Staff Report

Re: PLNPCM2017-00284 and PLNPCM2017-00486 – Expansion of an Existing Auto Body Shop

Conditional Use and Building & Site Design Review

PROPERTY ADDRESS: 1255 W 400 S

ATTACHMENT B: SITE PLAN

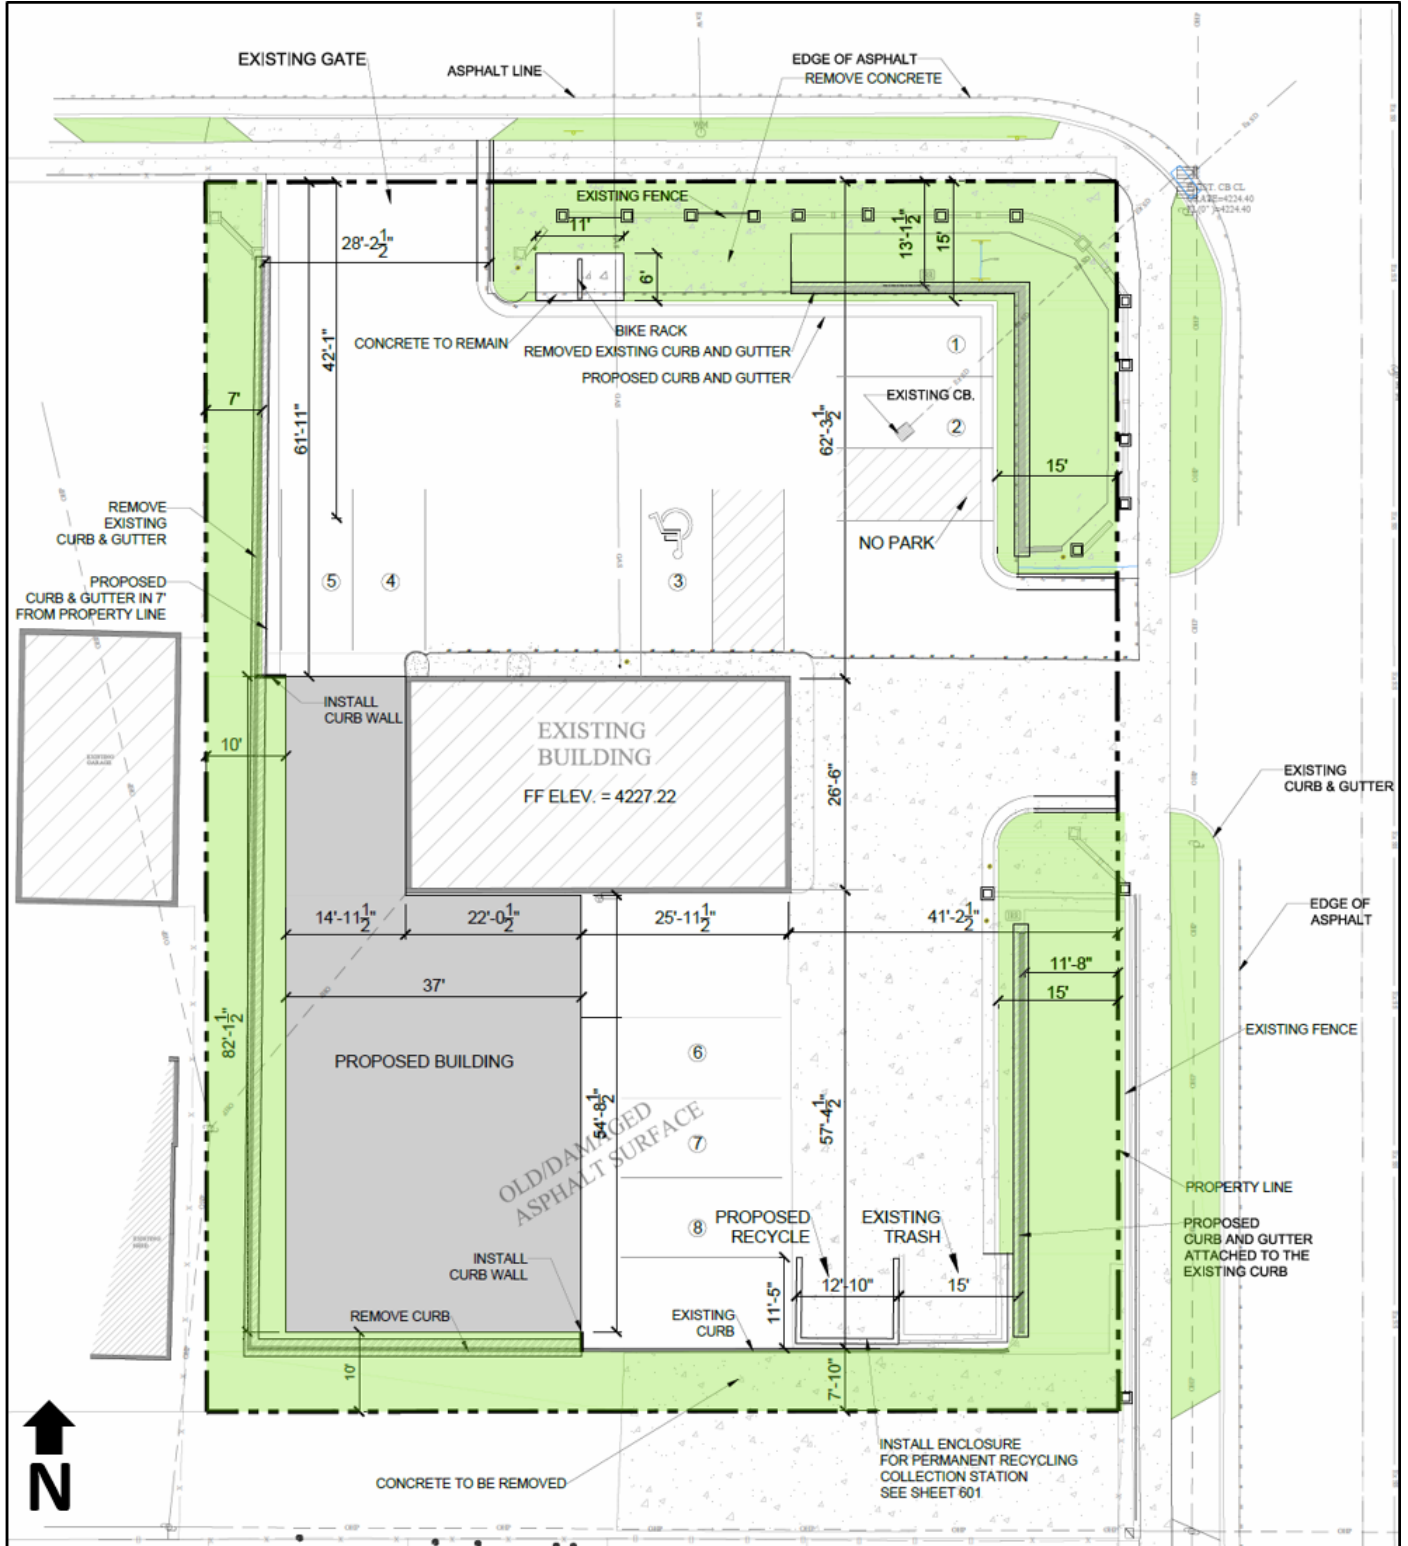
- 2) The curbing at the modified front yard landscaping area along 400 South needs to be returned to the public sidewalk at the east side of the driveway to separate the landscaping from the driveway.

- 3) The width dimension of the west side buffer from the face of the proposed structure to the public sidewalk is not identified (7’ minimum) nor is it, or the curbing, extended to the public sidewalk as required.

- 4) At the street side of the public sidewalk along 400 South, the drive approach width shall match the driveway width (modification of the existing drive approach may be required).

- 5) The south landscape buffer shows concrete within the required 7’ landscape buffer.
- 6) The Required 15’ corner side yard landscaping does not extend to the south property line landscape buffer line as required. Modification of the curbing, existing trash and proposed recycling container enclosure and parking to be modified accordingly and receive Transportation Div. review.

- 7) The Required 15’ corner side yard landscaping needs to be extended to provide a driveway width equal to the width of the existing drive approach as it crosses the public sidewalk, with curbing provided to separate the landscaped area from the driveway.

***NOTE: The plan set included in this staff report was revised and resubmitted after receiving this feedback. The updates appear to comply with the feedback given in this review. They will be verified by the Building Services division prior to issuing building permits.

ATTACHMENT E: LANDSCAPE PLAN

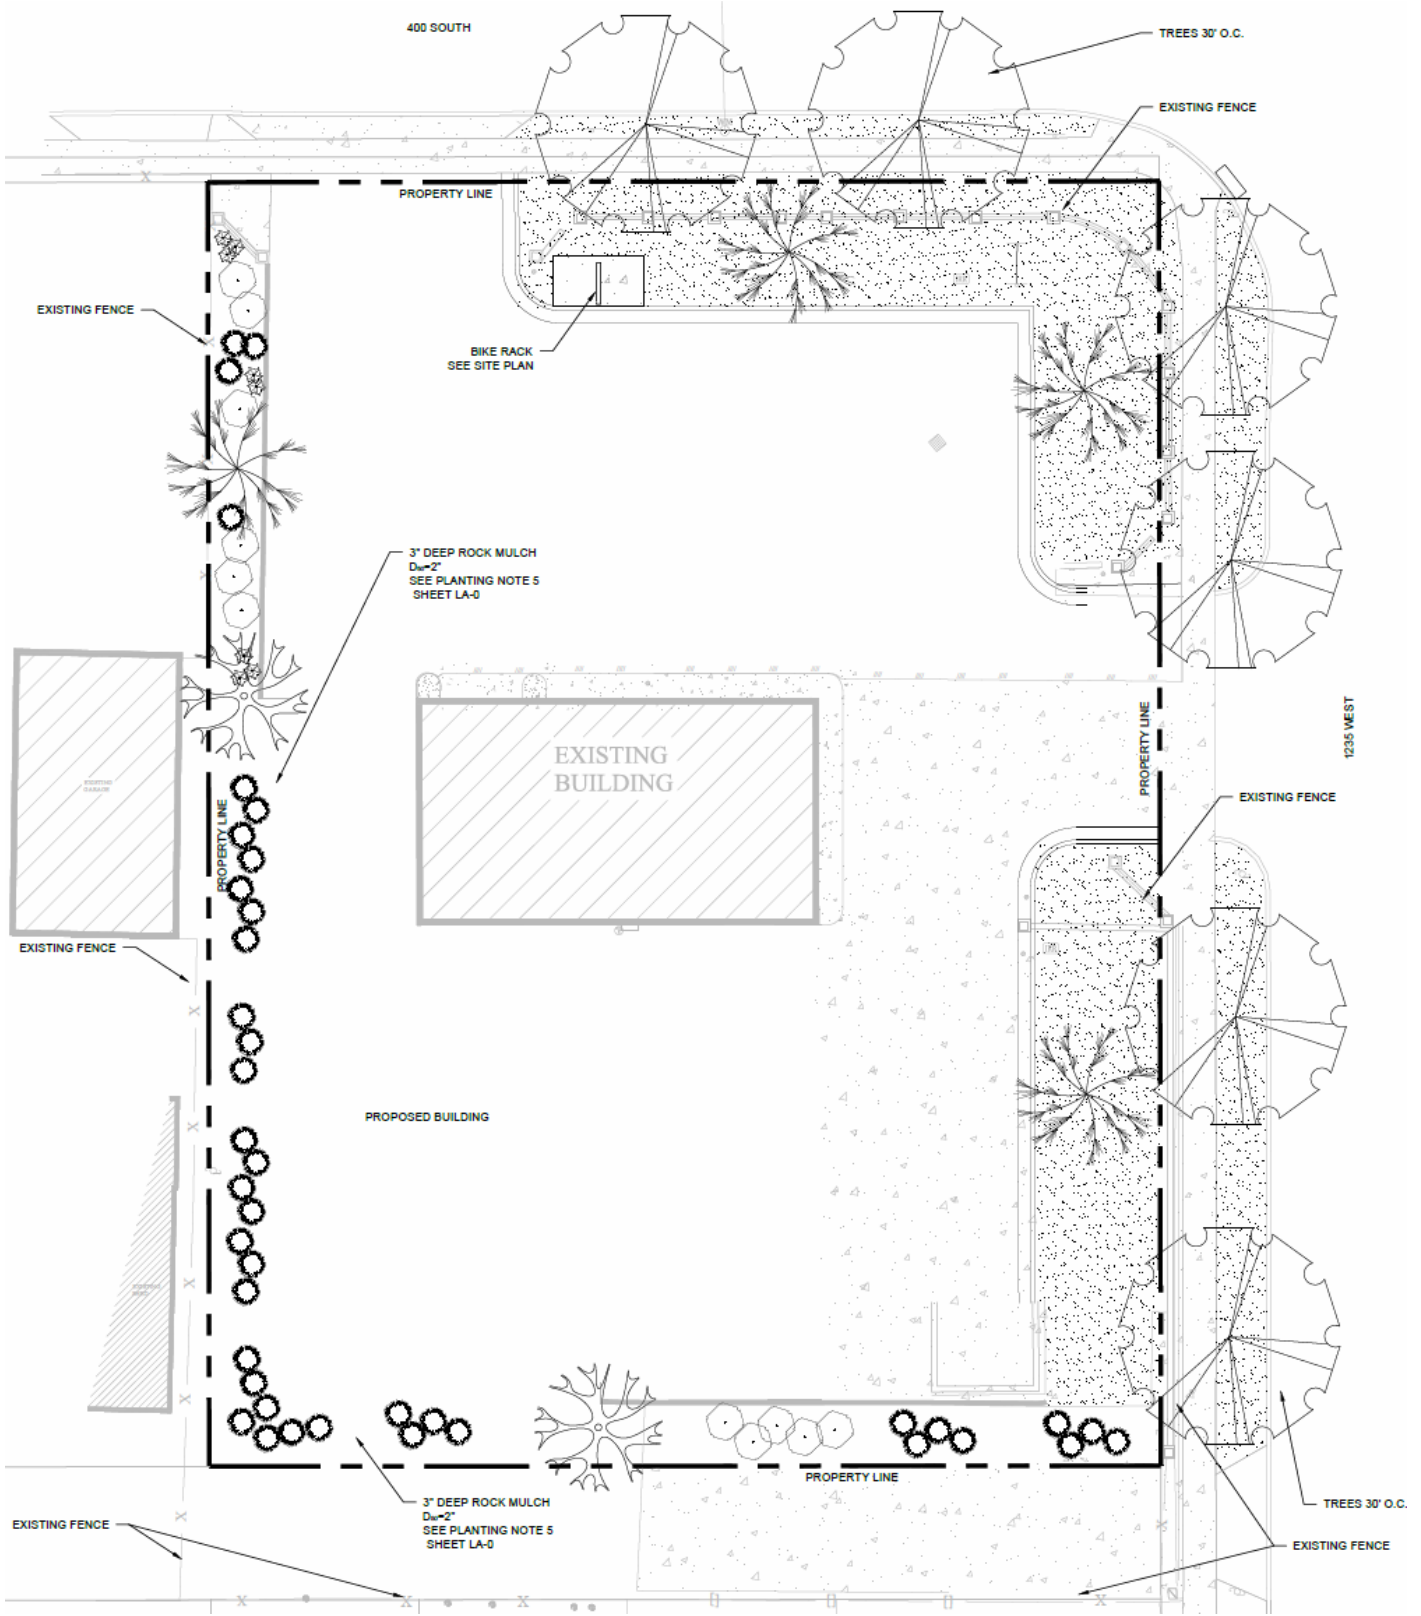
- 1) Only 2 park strip trees would be required in the 400 South park strip and 4 in the 1235 West park strip. One tree may be eliminated in the 1235 West park strip, however; Urban Forestry review is required for the species planned.
- 2) There is a 10’ x 10’ sight distance triangle at each side of each driveway and Picea abies Norway Spruce is generally not a good candidate for trees near a driveway. If the applicant wants trees near the driveways within the front and corner side yard landscaped areas, a different species is suggested, one that won’t mature at a size that will block the site distance triangle.
- 3) Landscape Buffer trees, shrubs, and fence required/provided based on 21A.48.080.
